# 1963 Corvette: Service News: Hydraulic Steering Hose Interference

**Subject:** 1963 Corvette Hydraulic Steering Hose Interference

**Source:** Chevrolet Service News

**Number:** Volume 34, Number 11, Page 2.

*Fig. 1—Adding Strap to Corvette Steering Hoses*

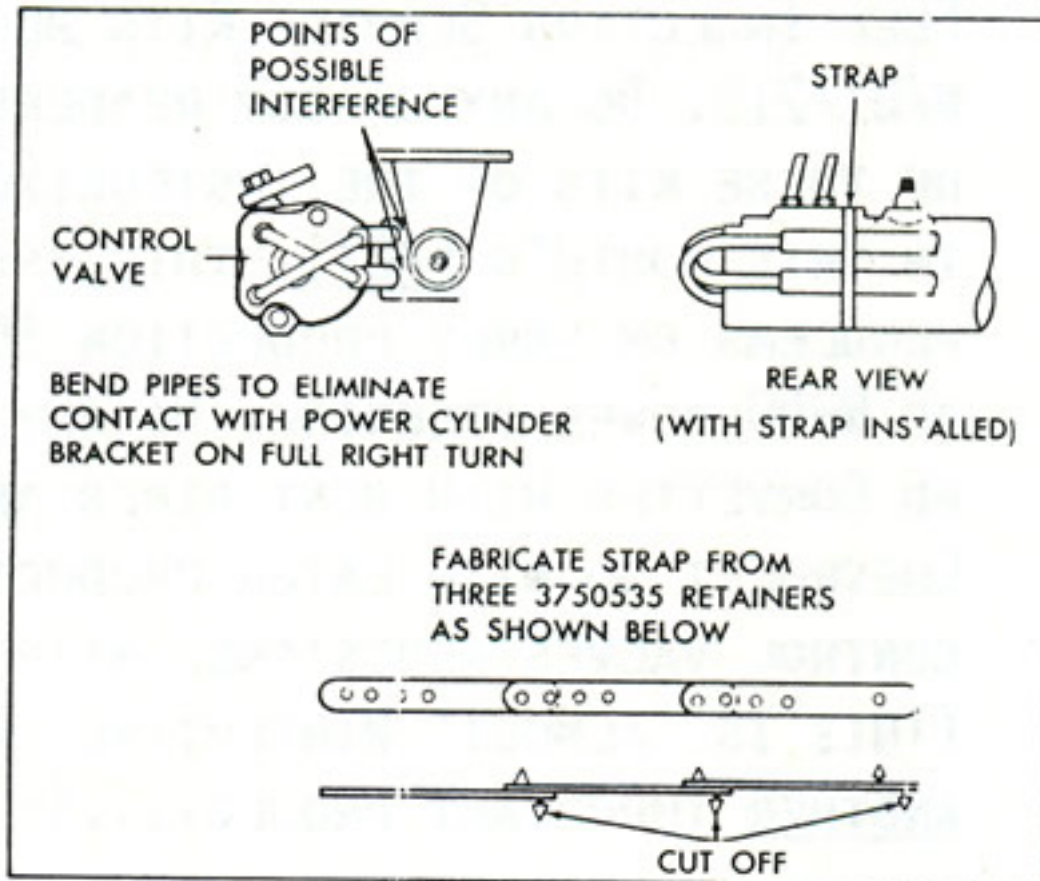
On early production 1963 model Corvette vehicles, interference, in some cases, may be encountered between the hydraulic steering control valve power cylinder hoses and the hydraulic steering cylinder frame bracket. This would occur when the wheels are moved into a full right turn. If this condition is experienced, the hose pipes at the control valve should be bent to provide clearance and then strapped with three Part No. 3750535 Retainers as shown in Figure 1.
